Changes to DR-55 PCB:

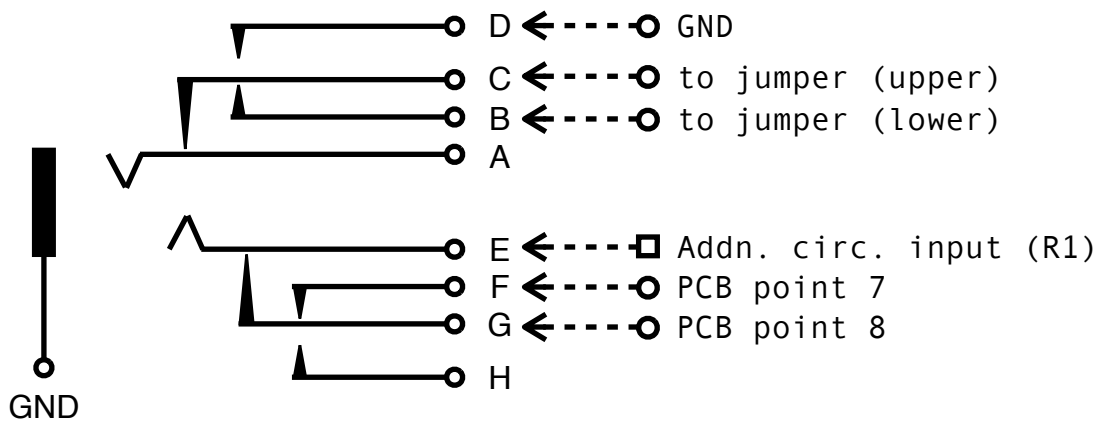
Replacement FS jack socket:

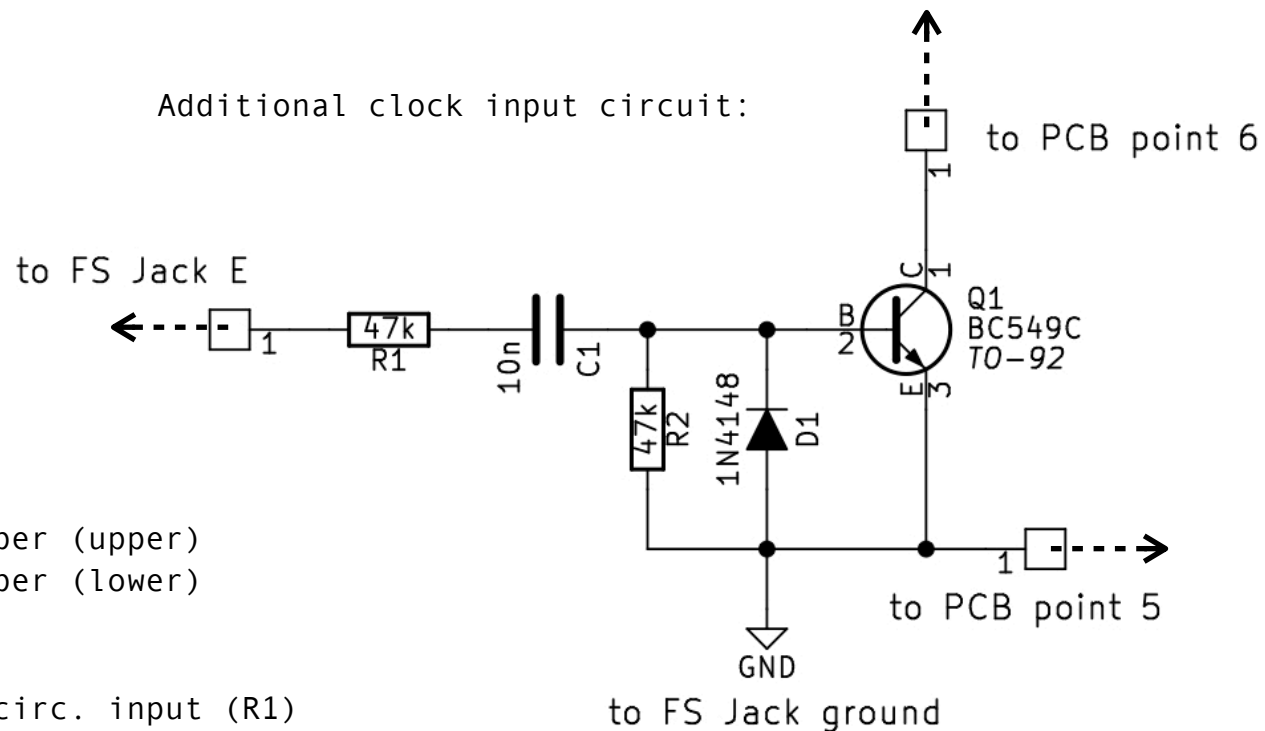
Additional clock input circuit:
